Site Instruction

SI 26

PROJECT : Hampton Manor
PROJECT No : 1136.13
DATE : October 10, 2018

Title: Addition of Roof Scuppers

COURTYARD ELEVATIONS
NORTH AND SOUTH FACING

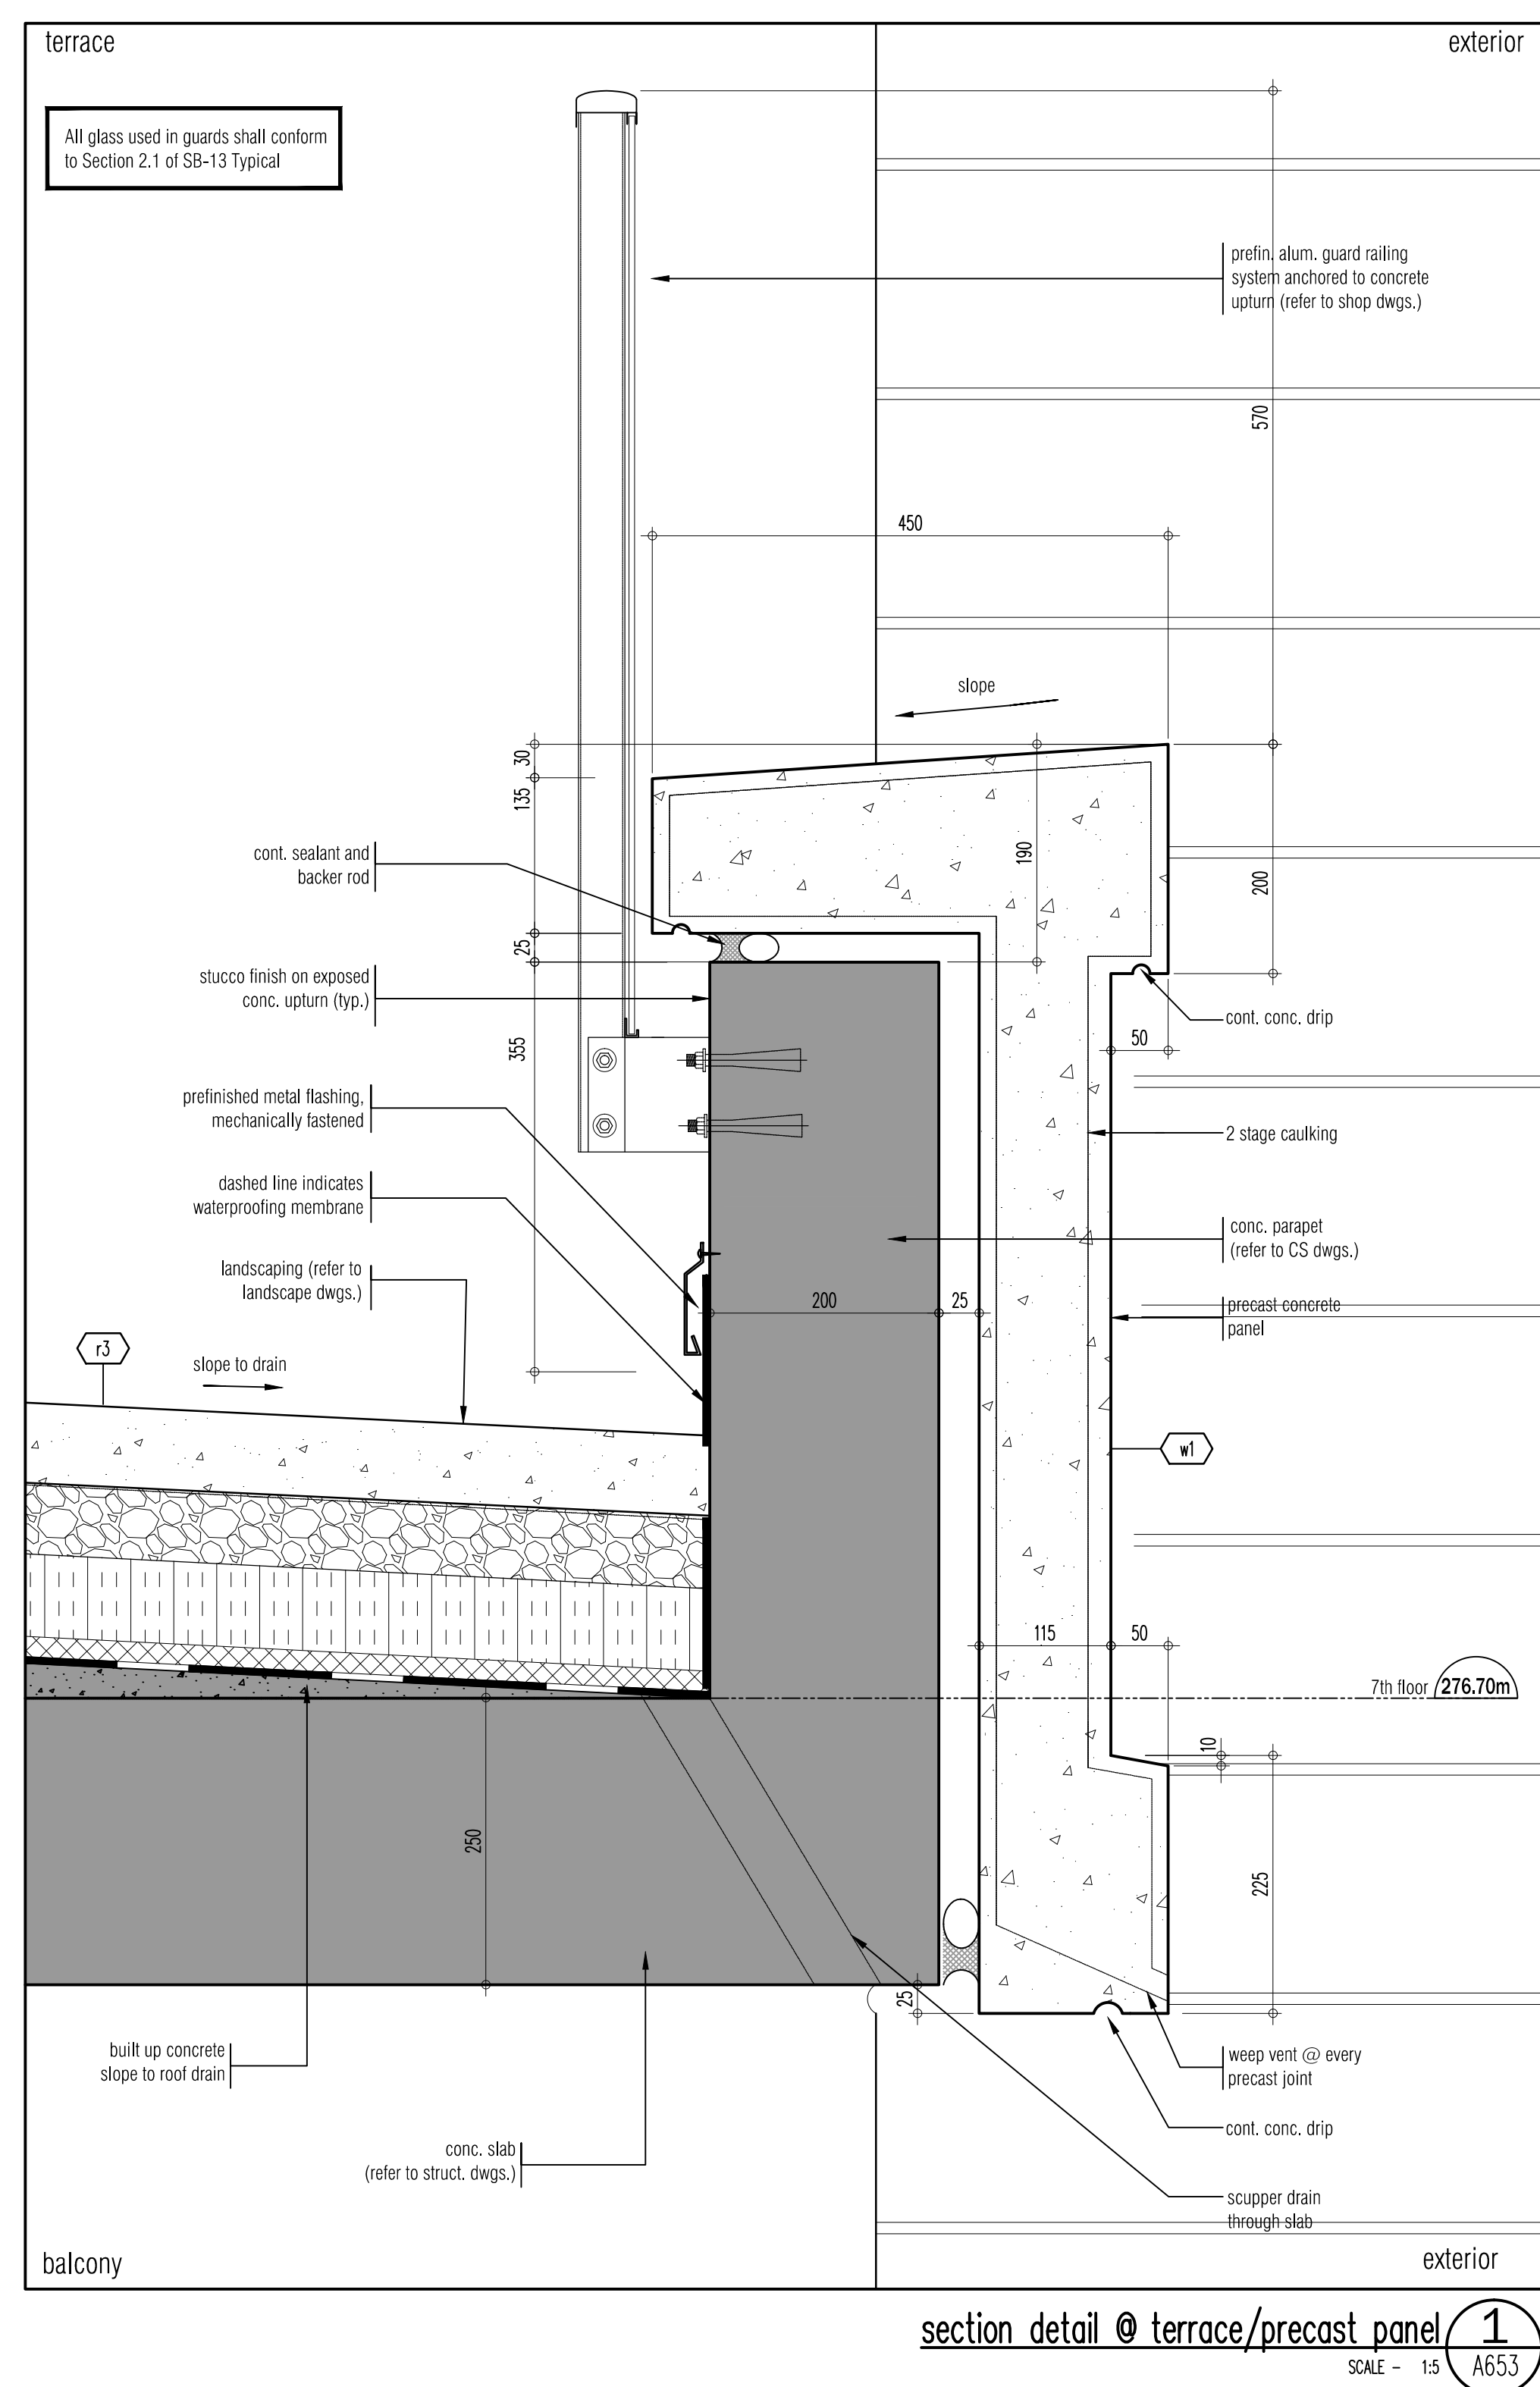
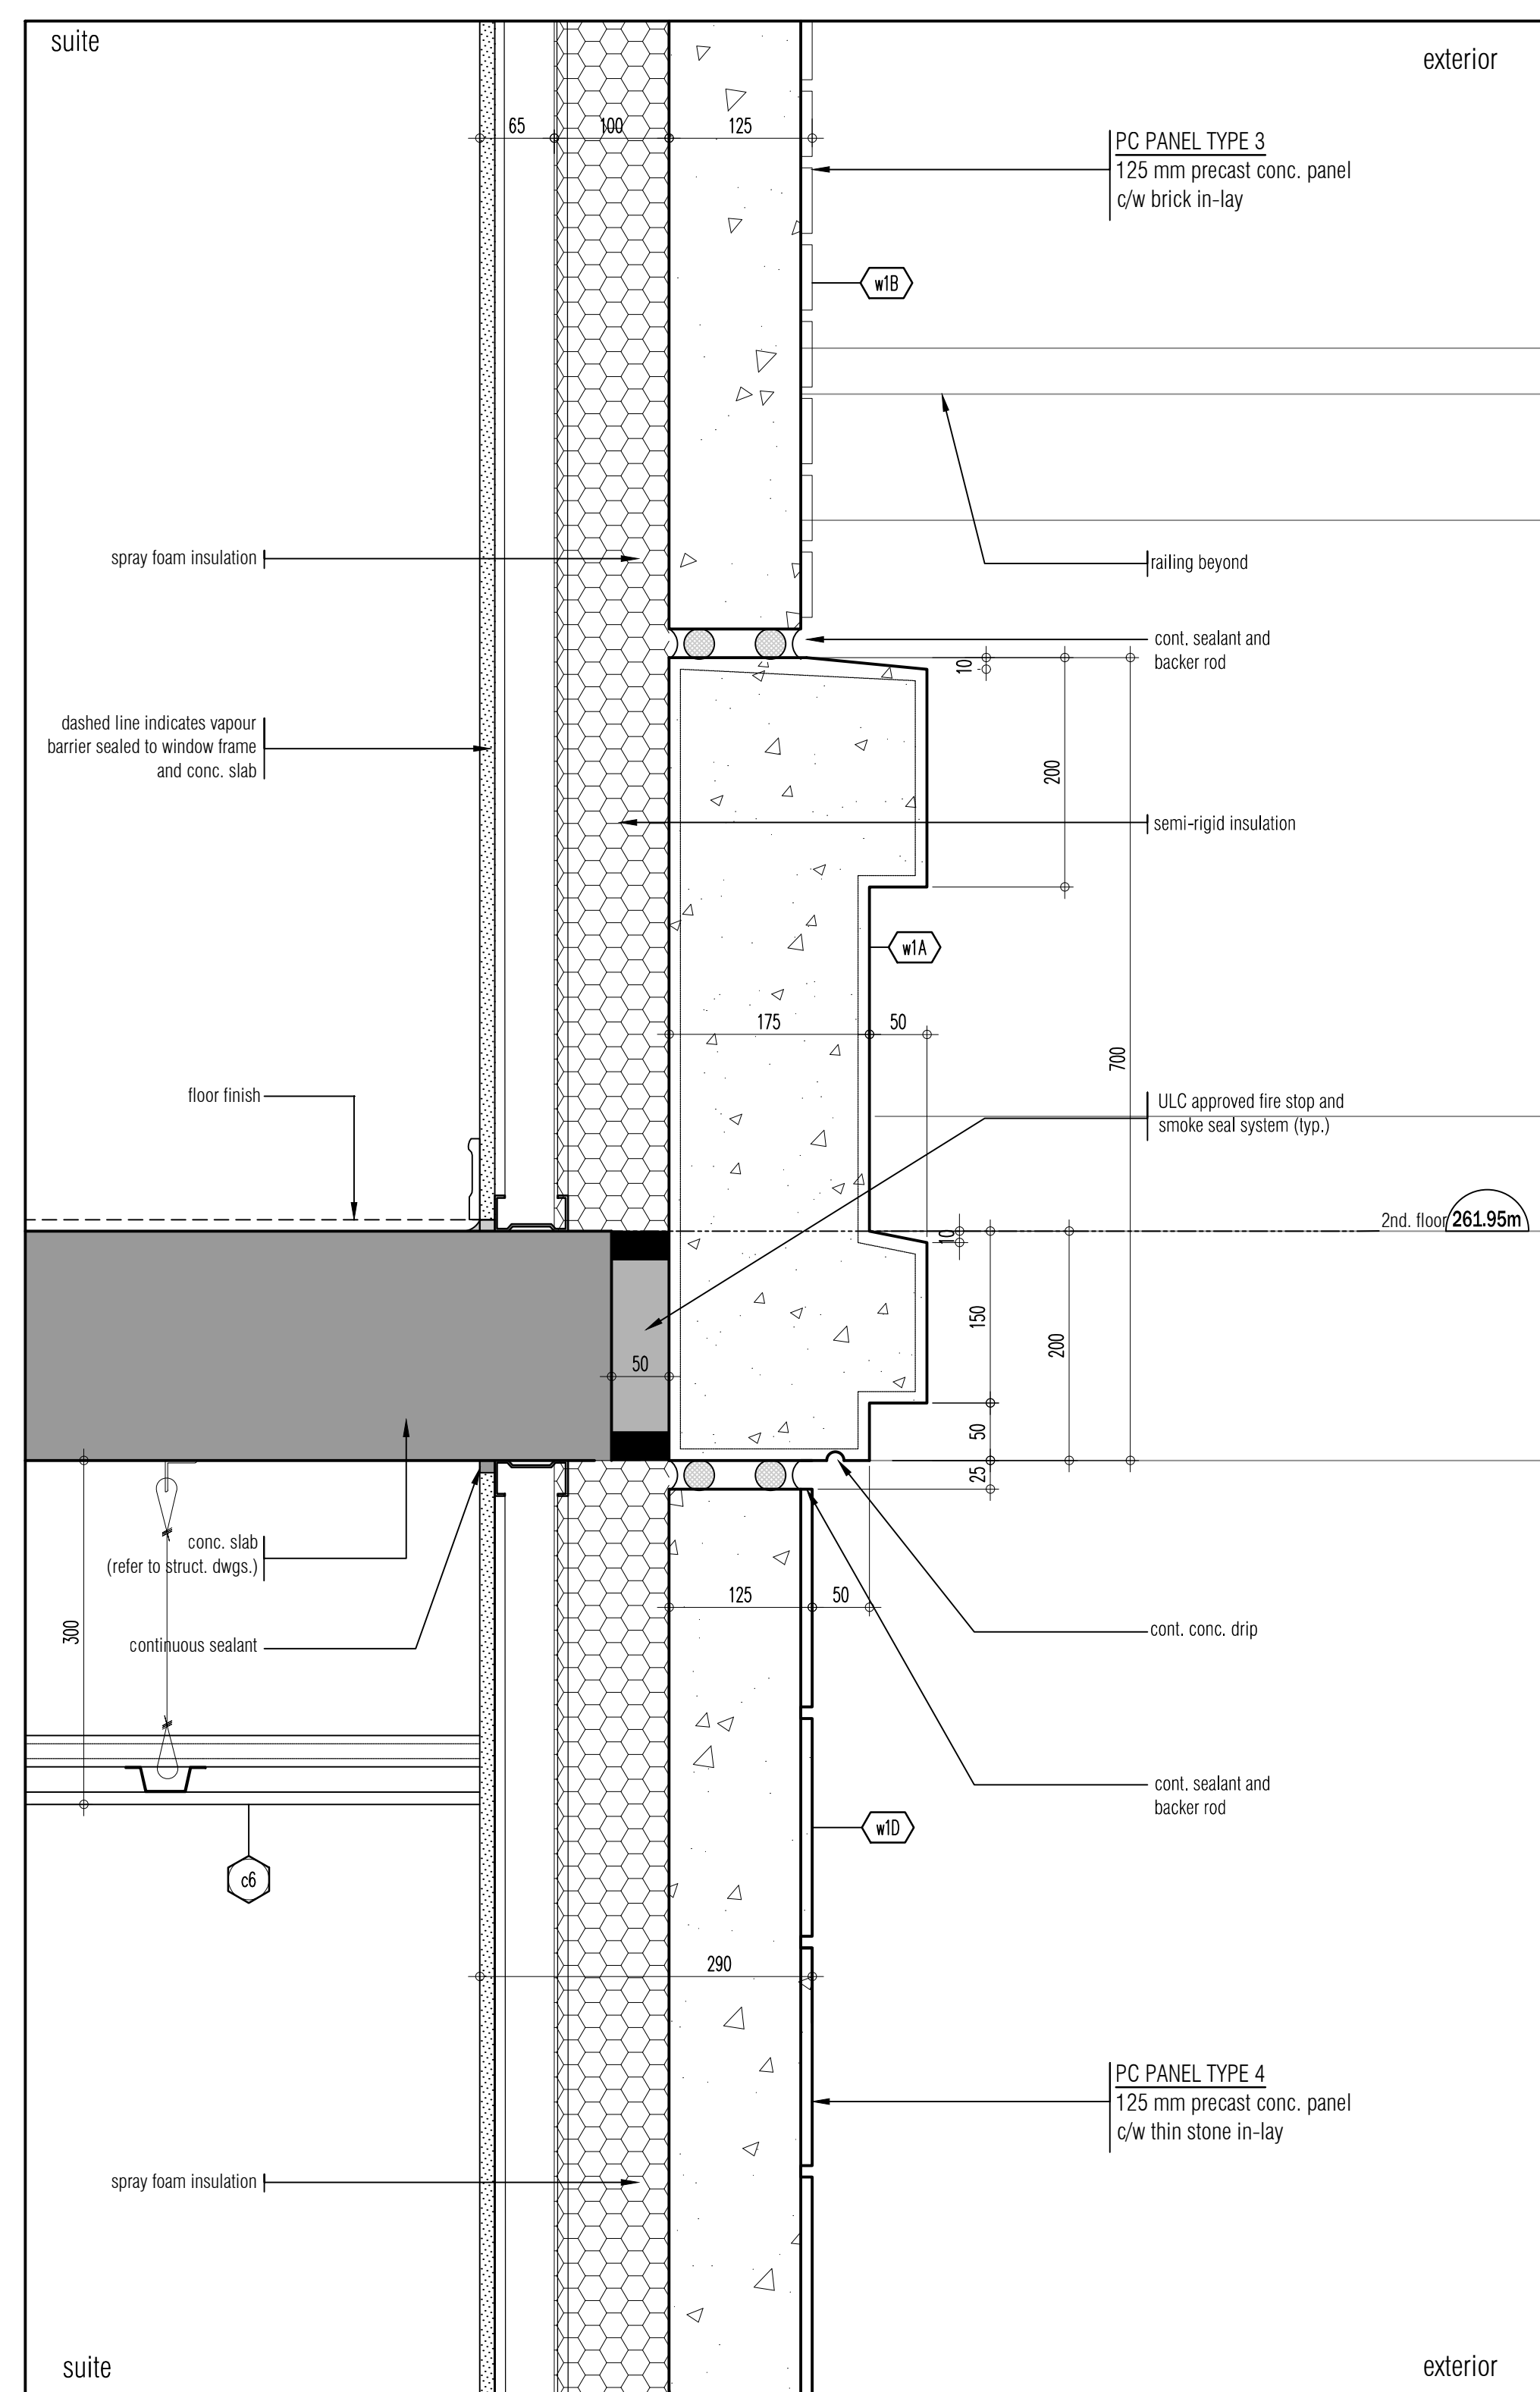
A401a-A401c – Building Elevations

- Adding Scuppers to Roof curbs
